## PETITION & LOCAL MEMBER OBJECTION

APPLICATION No. 18/02078/DCH DATE RECEIVED: 03/09/2018

LOCATION: 14 High Street, Llandaff, Cardiff, CF5 2DZ

PROPOSAL: ALTERATIONS TO PROVIDE HARD SURFACE, GATES AND REBUILD WALL PILLARS

A102

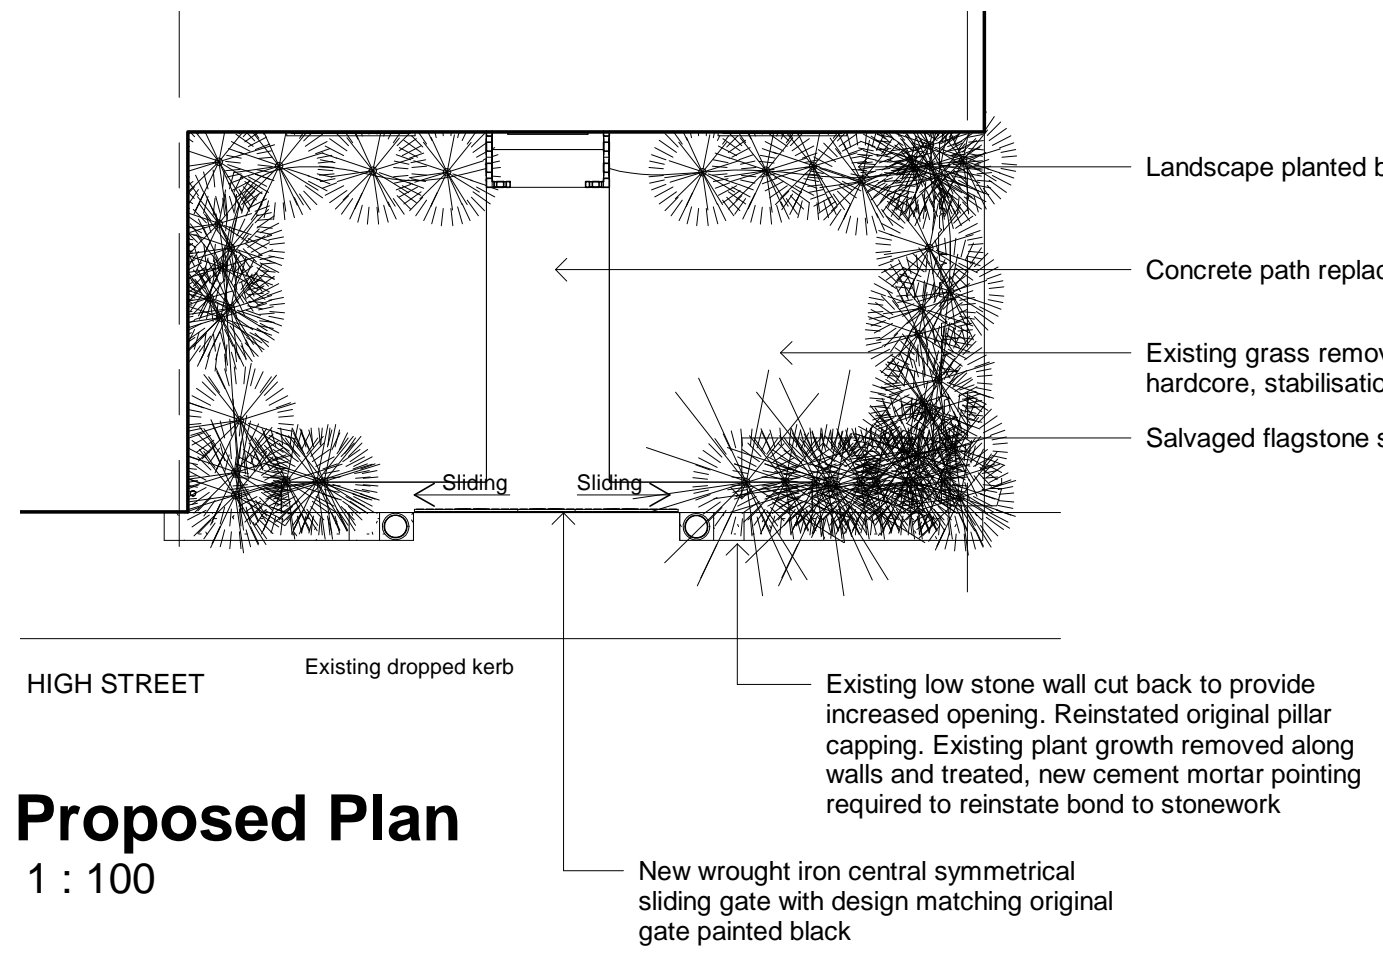
- 1 C01 – Statutory Time Limit
- 2 The development, other than expressly detailed at conditions 3 and 4, shall be carried out in accordance with the approved drawing numbered A102.  
Reason: To ensure satisfactory completion of the development and for the avoidance of doubt in line with the aims of Planning Policy Wales to promote an efficient planning system.

- 3 Prior to the commencement of the development, hereby approved, notwithstanding the approved drawing details of the extent of the hard surface and its finish, which shall precisely confirm the areas of gravel, shall be submitted to and approved by the Local Planning Authority and the development shall thereafter accord with the approved details.  
Reason: To ensure the character of the Llandaff Conservation Area is preserved in accordance with Policy EN9 of the Local Development Plan.

Measurement of the scaled drawings with the application suggests the distance between the edge of the porch to the footway is 4.2 metres which is less than the 4.8 required. The proposed planting, indicated to attempt to reduce the negative visual impact of the development, would also reduce the total space further. The document A104 - Proposed View submitted to support the application gives an entirely false impression of the size of the space and the way in which vehicles could be parked facing the building. This must be addressed with full and proper consideration.

- b) Impact upon Highway Safety: It is considered the proposal would not have any adverse impact upon highway safety. The Council's Highways section have agreed the installation of the vehicular crossover, allowing vehicular access to the front curtilage with the property. The distance between the front elevation of the building and the front enclosure has been measured on site as 5 metres which confirms the scaled proposed plan drawing as accurate. Whilst the distance from the porch to the footway is less than the minimum of 4.8m as recommended by the Highways section to ensure vehicles do not overhang the footway, in this particular instance it should be possible to park at an angle without the vehicle overhanging the footway.
